Access Compliance Report

Public Rights-of-Way

Intersection ID: 46346	Main Street: MEADOW_KNOLL_DR	Cross Street: MINT_THISTLE_CT	Location: SE
ADA ID: A4F9078FEE59	Ramp Type: PerpDiag	Initial Pass/Fail: Pass	Overall Compliance: No
Severity Score: 0.25			
Codes/Mitigation Info/Possible Solution		Field Measurements/Component Compliance

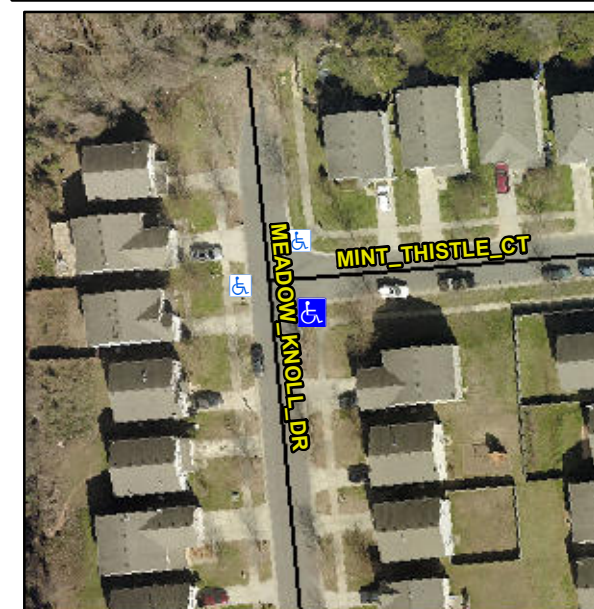
Not Found, R304.5.3, R304.2.1, R304.2.2-Perp, R304.3.2-Para, R305.2

Compliance	Description	Data	Compliance	Description	Data
N/A	Ramp Length (in)	85.0	Yes	Ramp Slope (%)	6.3
Yes	Ramp Width (in)	48.0	No	Ramp XSlope (%)	3.2
N/A	Flare Type LT	Sloped	N/A	Flare Type RT	N/A
N/A	Flare Slope LT (%)	2.4	N/A	Flare Slope RT (%)	7.2
N/A	Flare Traversable LT?	No	N/A	Flare Traversable RT?	No
Yes	Landing Length (in)	58.5	Yes	DWS Provided?	Yes
No	Landing Width (in)	45.0	Yes	DWS Contrast?	Yes
No	Landing Slope (%)	2.1	Yes	DWS Length (in)	24.0
No	Landing X Slope (%)	3.9	Yes	DWS Full Width?	Yes
N/A	Landing Curb? (Y/N)	No	No	DWS Offset (in)	3.0
N/A	Shared Landing?	No			
Yes	Gutter Ponding?	No	Yes	Gutter Slope (%)	2.7
Yes	Gutter Lip Ht (in)	0.0	No	Gutter X Slope (%)	2.4
N/A	Painted X Walk1?	No	N/A	Painted X Walk2?	No
	X Walk 1 Direction	To N		X Walk 2 Direction	To W
N/A	X Walk 1 Width (in)	N/A	N/A	X Walk 2 Width (in)	N/A
	X Walk 1 Slope (%)	3.6		X Walk 2 Slope (%)	4.7
	X Walk 1 X Slope (%)	3.8		X Walk 2 X Slope (%)	0.7

Remove & Replace Curb Ramp With Two New Directional Ramps or Equivalent. Remove & Replace Gutter.
